REMARKS

AMENDMENT TO THE DRAWINGS

CONTAINMENT DEVICE AND METHOD FOR HOSE BIBS AND THE LIKE
Annotated Marked-Up Drawings
Patent Serial No. 10/748,768
Inventor: Commeville et al. Atty Docket No. 31141-2
Response to Office Action (dated 12/16/04)
Contact: Troy J. Cole (317) 634-3456

Fig. 3

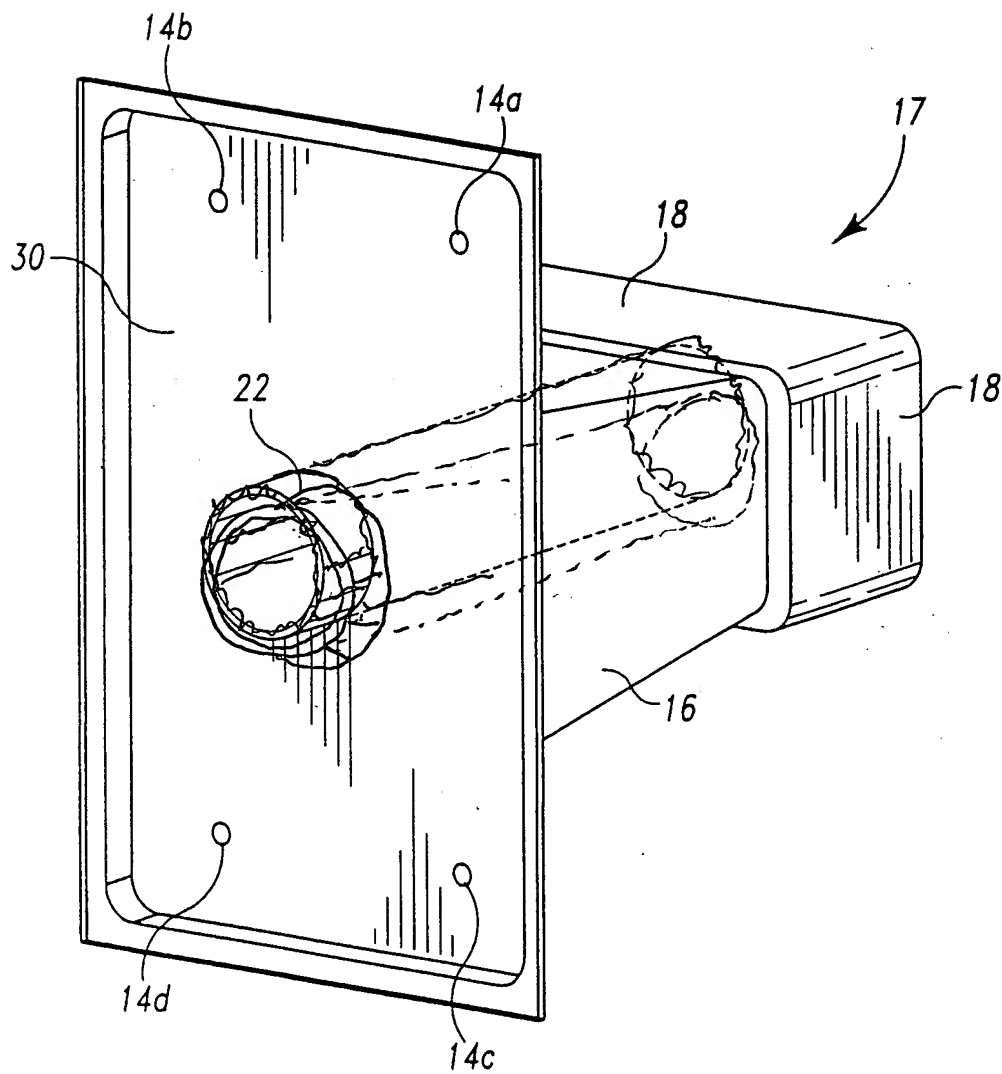
The Office Action rejected FIG. 6 for the failure to indicate that the hose bib illustrated is prior art. In addition, the drawings were objected to because in FIG. 3 hole 22 was incorrectly extended out of middle portion 16. The Applicants have amended the drawings in light of the Office Action suggestions. The designation (Prior Art) has been added to FIG. 6. The Applicants respectfully traverse the objection to FIG. 3. All of the lines for the hole 22 were dashed, indicating the structure is hidden within the middle and front portions. The Applicants, however, have amended FIG. 3 to make the perspective more accurate. The new drawings are included as Replacement Sheets in Appendix A and the changes are highlighted in the Annotated Marked-Up copies in Appendix B.

The attached sheets of drawings include changes to FIGs. 3 and 6 and replace the original sheets for FIGS. 3 and 6. In FIG. 3 the hole 22 has been revised to no longer extend out of the middle portion 16 and the designation (Prior Art) has been added to FIG. 6.
